**ADDENDUM #5**

PROJECT : CODESTACK ACADEMY

REF. # : ARCH PROJ. No. 2023-04

DATE : 6 December 2024

**A** Section - grid I at F-H.1/J.1-L  
 1/4"=1'-0"

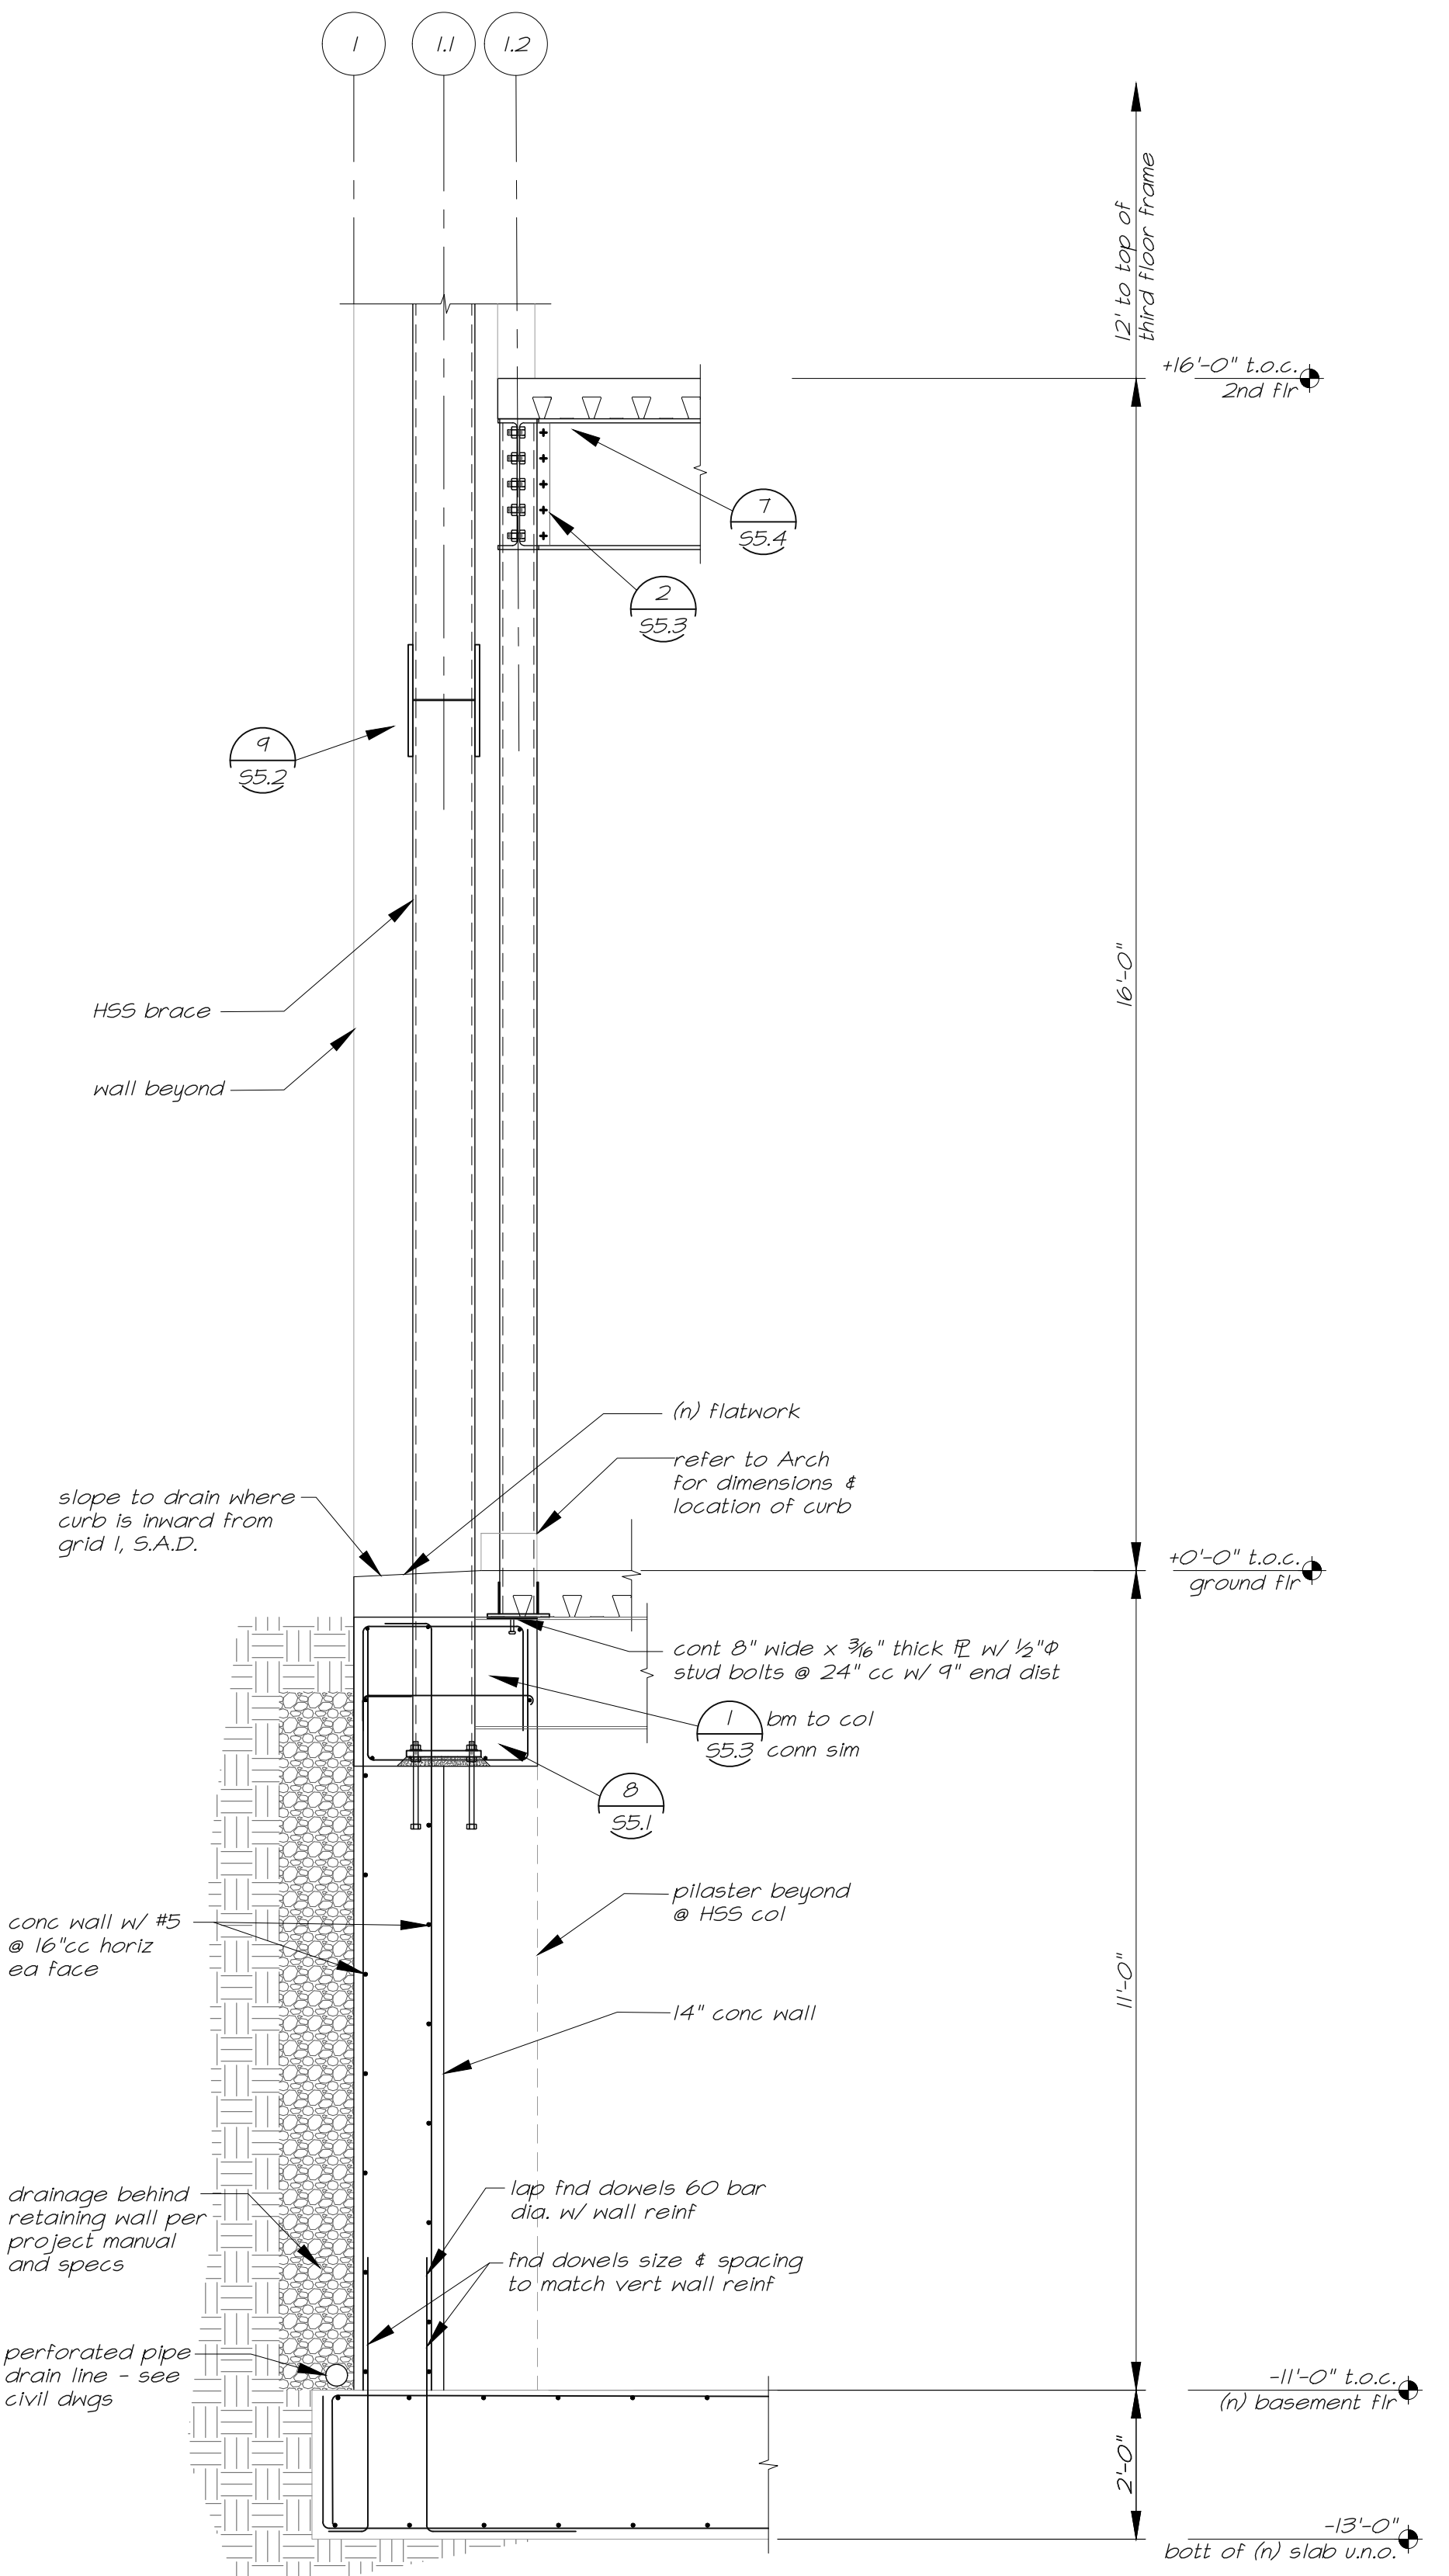
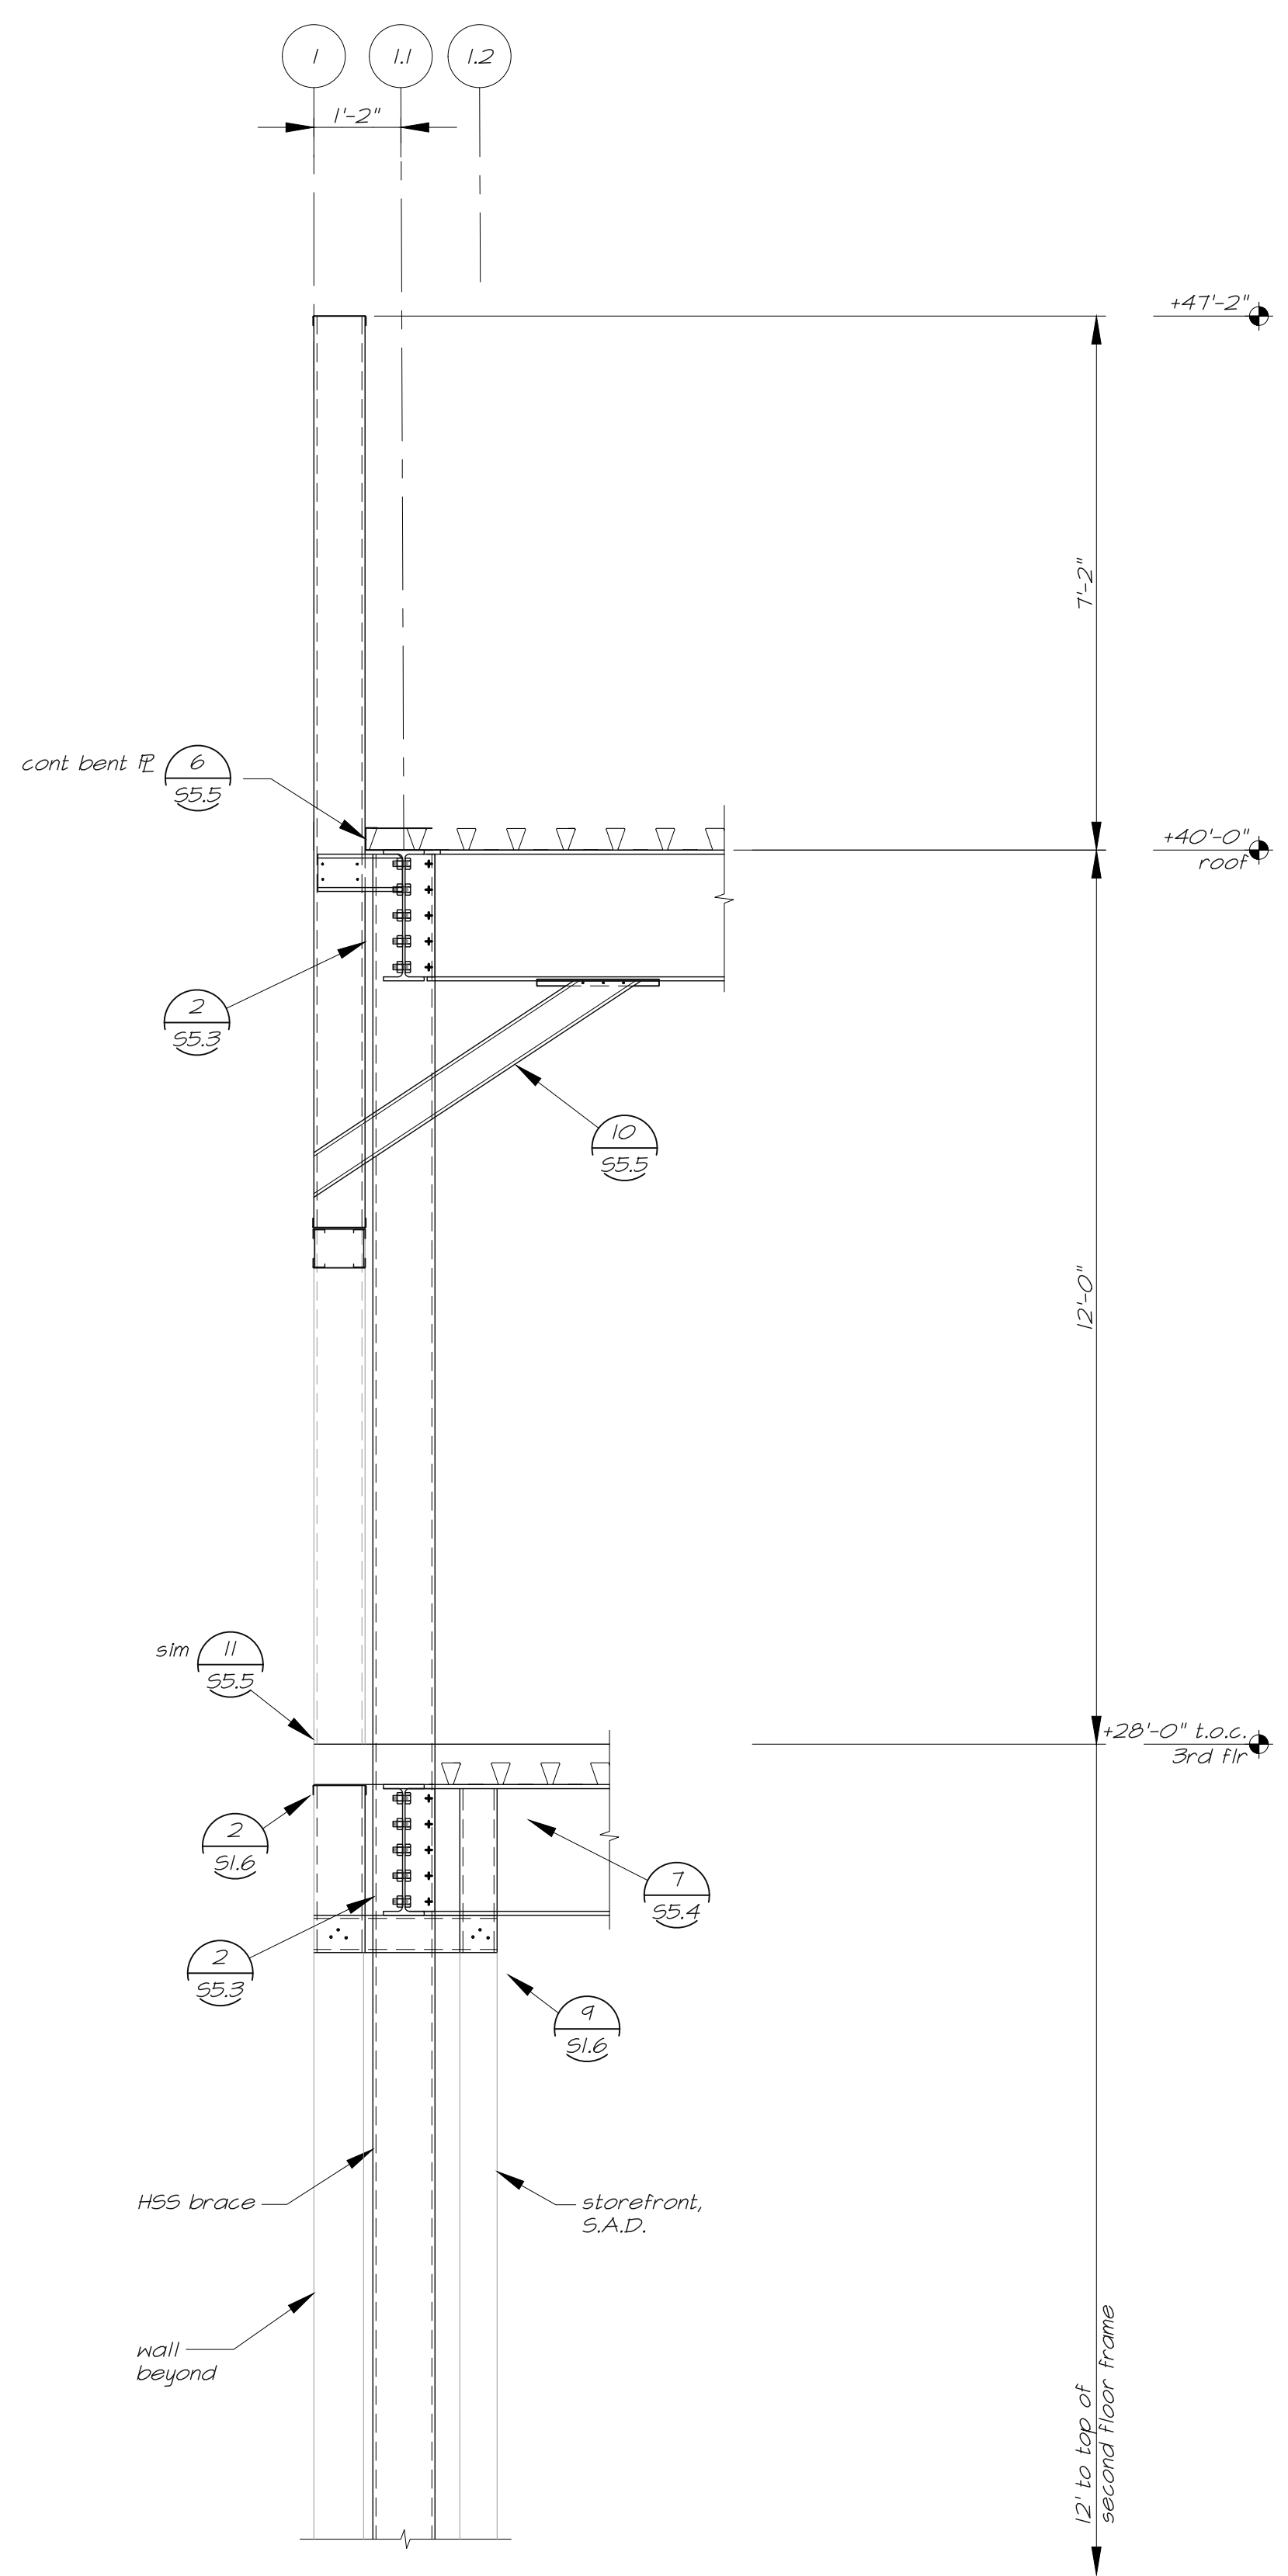
REQUESTED CLARIFICATION:
<p>5)Second Floor plan S2.3. There appear to be pop outs along grid but all column base plates are shown only on Line 1.1Both W18x50 braced beams shown in B&amp;C/S3.2 Line 1.1 are shown inset on plan towards 1.2. Section cuts on this line A/S4.2 are very obviously unfinished, Please clarify pop outs on Line 1.1 and Line 1.</p>

RESPONSE TO CLARIFICATION:
<p>See B/S4.2</p>

**3** HSS Braced Frame Base Plate Connection Schedule

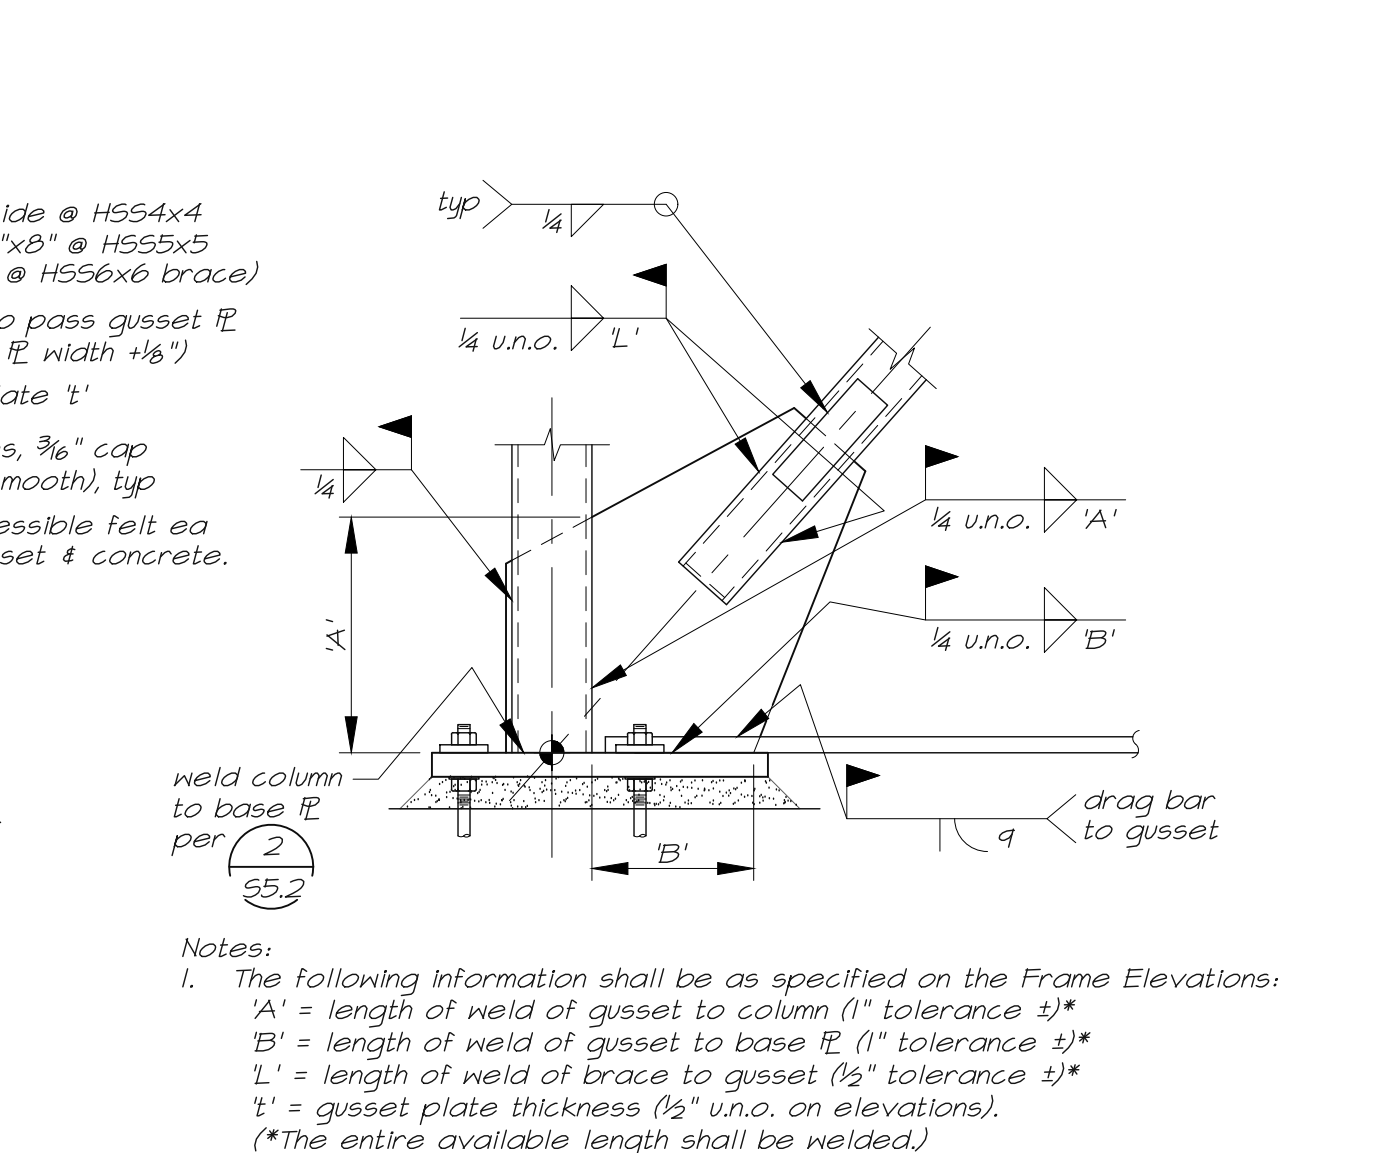
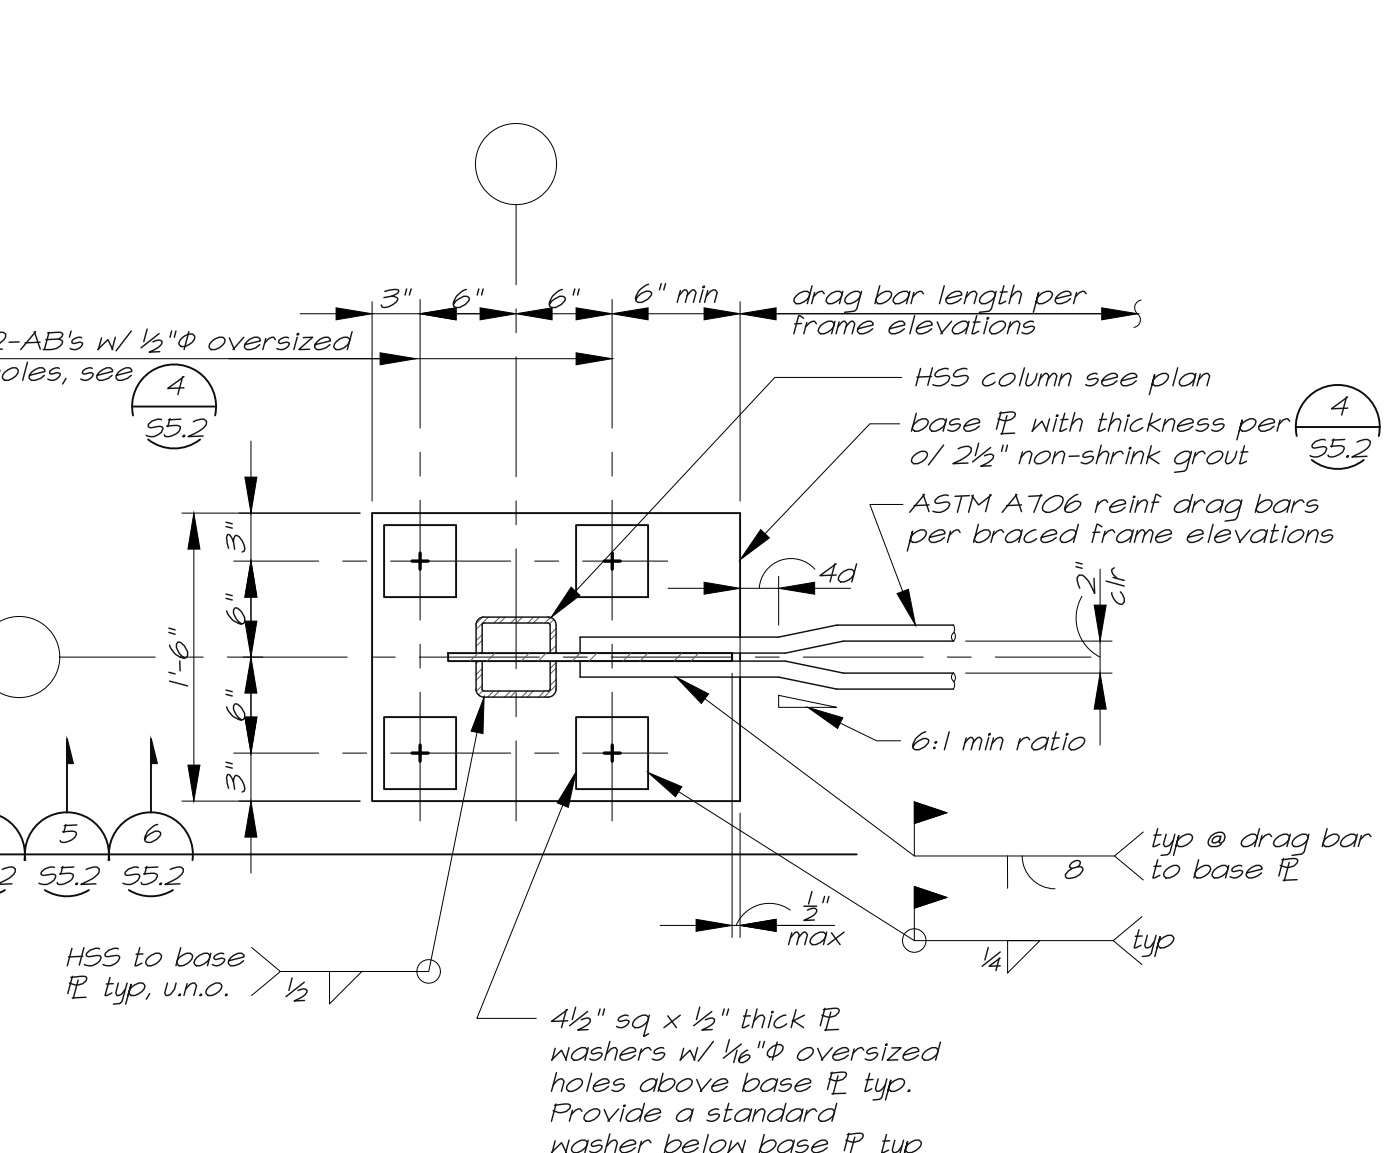
REQUESTED CLARIFICATION:
<p>3) Braced frame details drawing S5.2 has many issues. Det 3/S5.2 provides base plate thickness for 3 sizes of HSS columns but it does not provide for HSS 7x7 or 8x8 columns with varying wall thicknesses, anchor bolt info is also needed for the larger HSS sizes, see also details 7&amp;8/S5.2 which show different details for HSS5x5 and HSS6x6 braced column bases. Again no details for HSS7x7 or HSS8x8. Details 1&amp;2/S5.2 call out drag bars welded to braced base plates and say “per braced frame elevations” drag bars are not called out in elevations S3.1-S3.3. There are other typos on this S5.2 but this drawing simply needs to be finished or provide all missing or conflicting info.</p>

RESPONSE TO CLARIFICATION:
<p>Drawings have been updated.</p>
